# COMMUNITY DEVELOPMENT DEPARTMENT

SUBJECT: FP-2021-0004

Apex Northwest No. 1 - FP

#### PLAT OF APEX NORTHWEST SUBDIVISION No. 1

# B. Final Plat (dated: 2/22/21)

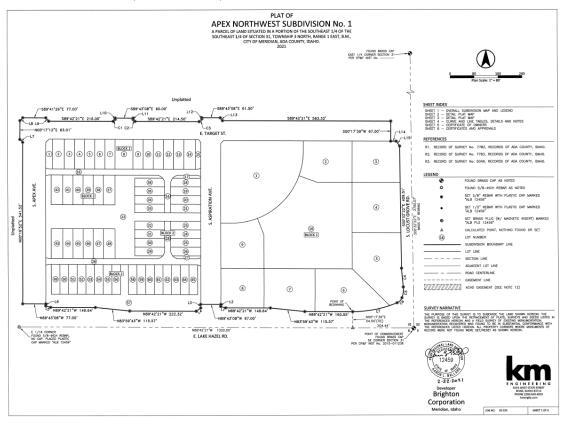
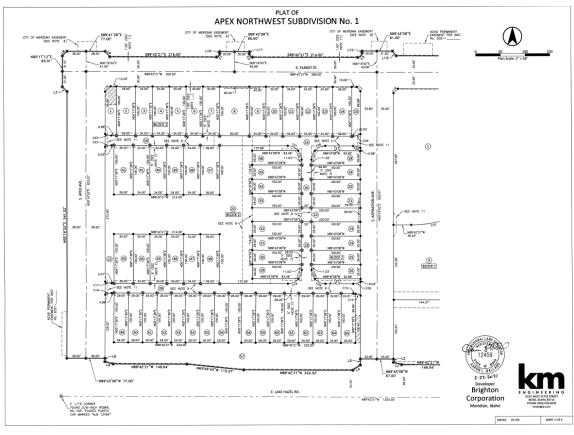
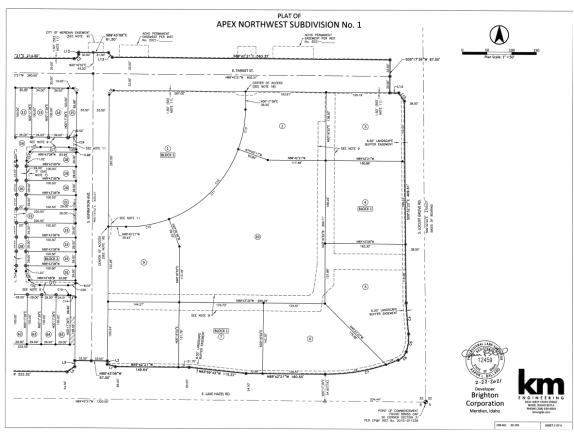
- 3. Prior to submittal for the City Engineer's signature, have the Certificate of Owners and the accompanying acknowledgement signed and notarized.
- 4. The final plat prepared by KM Engineering stamped by Aaron L. Ballard, dated: 2/22/2021, included in Section V.B shall be revised as follows:

- a. Rename E. Target St. to E. Phenomenal St. consistent with Ada County Street Name Review approval.
  - b. Include the CP&F recorded instrument number at the corner section on Sheet 1.

- c. Include the recorded instrument number of the ACHD permanent easement graphically depicted on Sheets 2 and 3.
  - d. Depict zero (0) setback lot lines where attached dwellings span across property lines.

- e. Depict PUDI easements along rear lot lines and/or the subdivision boundary of lots in Block 2, as applicable.
  - f. Reconfigure the eastern portion of Block 2 consistent with that shown in Section V.E. Notes:

- g. Note #8: Include information for PUDI easements along rear lot lines and/or the subdivision boundary of lots in Block 2, as applicable.
  - h. Note #9: Include the recorded instrument number of the City of Meridian easement.

- i. Note #10: Include the recorded instrument number of the ACHD landscape license agreement.
  - j. Note #11: Include the recorded instrument number of the ACHD public right-of-way (sidewalk) easement.

- k. Note #18: Replace E. Target St. with E. Phenomenal St.

# D. Emergency Access Exhibit

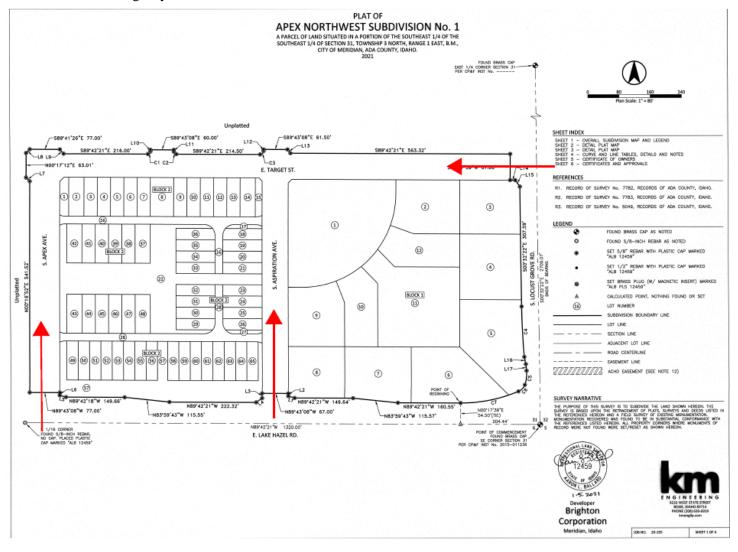
The proposed emergency access exhibit in Section VIII.D has been approved by the Fire Dept.

# E. Proposed Reconfigured Lot Layout

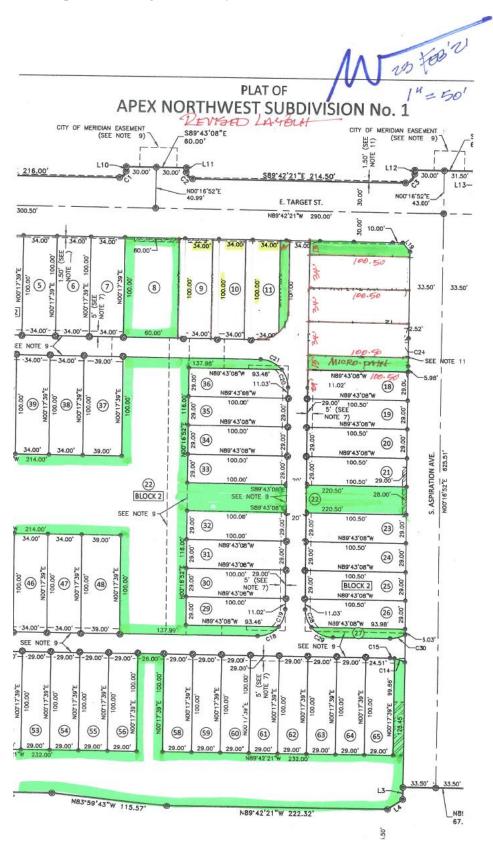
The north/south alley depicted on the preliminary plat in Block 2 wasn't approved because it's not visible from a public street as required by UDC 11-6C-3B.5e. As suggested by Staff, two common driveways were initially proposed with the final plat in lieu of the alley; however, because the number of units served by the common driveways exceed the maximum number allowed, it was not a viable option. As an alternative, the Applicant submitted a conceptual drawing that shows how the three lots at the northeast corner of Block 2 can be reconfigured and a north/south alley provided in place of the common driveways which is visible from a public street as required. Because this option meets UDC standards, Staff is supportive of this revision (see Section V.E).
